Hawkins Plaza Unit 2

City of El Paso — City Plan Commission — 12/6/2018 SUSU17-00039 — Major Combination (REVISED)

Street Right-of-Way Modification Request

MAJOR ARTERIAL STREET WITH BIKE\HIKE

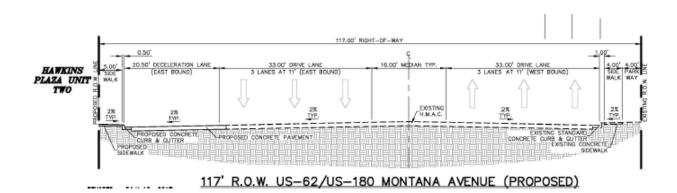
1. To waive the required 10' bike and hike improvements along Montana Avenue.

There are no existing bicycle facilities within ¼ mile of the subject property. The applicant will be installing a 5' sidewalk in lieu of the bike and hike.

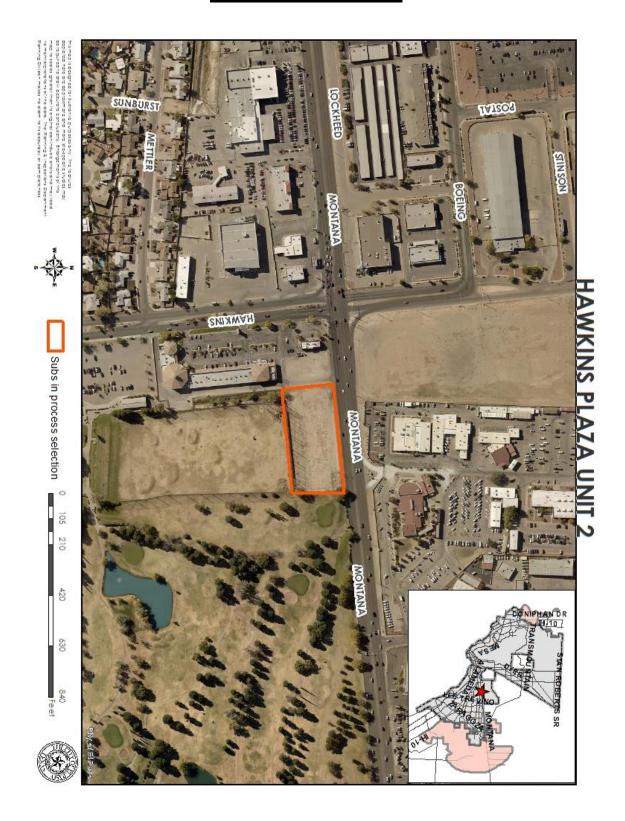
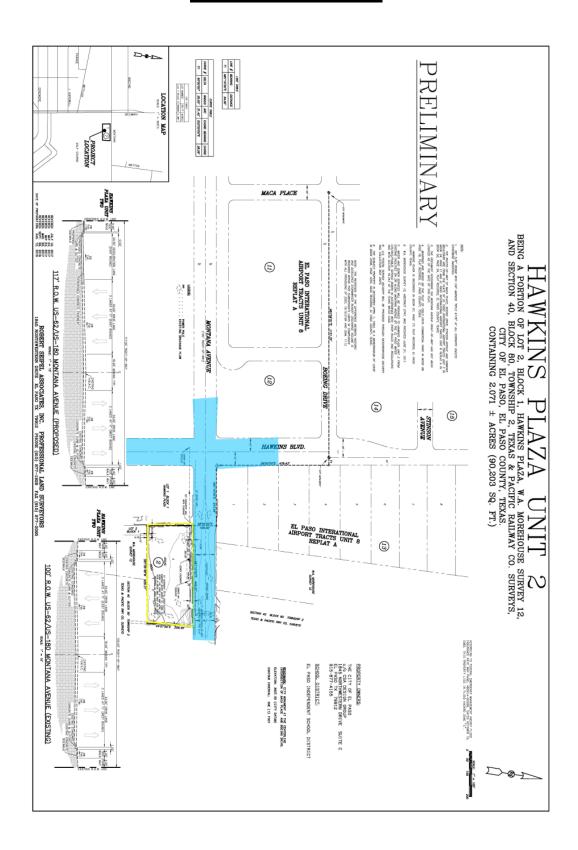
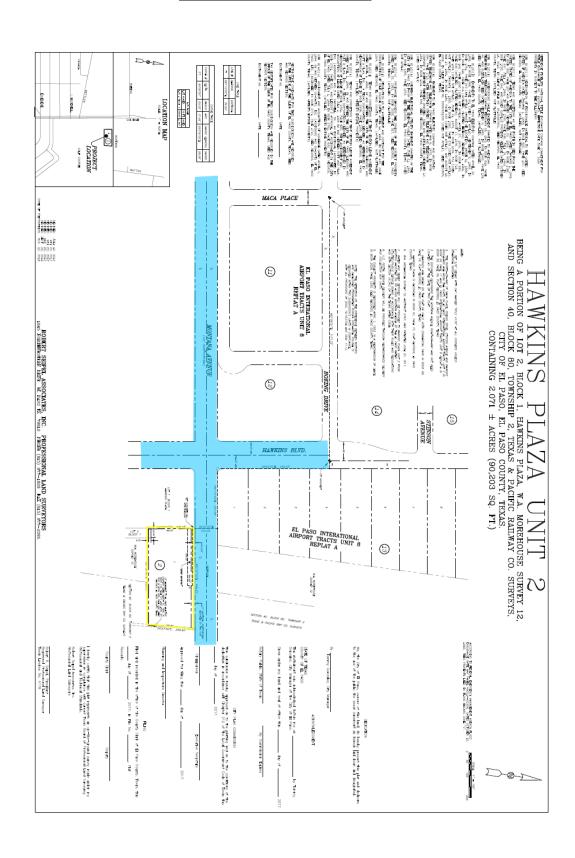
- 1. At the improvement plan stage, provide protection to the subdivision from all offsite stormwater runoff that may have an adverse impact on any improvements.
- 2. Verify if additional ROW line is to follow the new deceleration line curve.

- A 35' driveway with deceleration lane was approved by the Access Management Committee.
- TxDOT recommends a regular 5-ft sidewalk. TxDOT has no plans for a hike and bike in the area.

- 1. The Consolidated Review Committee (CRC) reviewed and approved a Preliminary Building Scale Plan at this location on March 28, 2017.
- 2. The cross-section for Montana Avenue should match layout depicted on the approved Preliminary Building Scale Plan.
- 3. A Final Building Scale Plan shall be submitted for review by the CRC prior to the issuance of building permits.

1. Please label 20' sewer easement as 20' PSB easement.

There is an existing bus stop adjacent to the subject property. Please coordinate with Sun Metro for the relocation and installation of the bus stop as it will need to adhere to the current bus stop design standards. The current bus stop design standards require an 8' by 40' bus pad
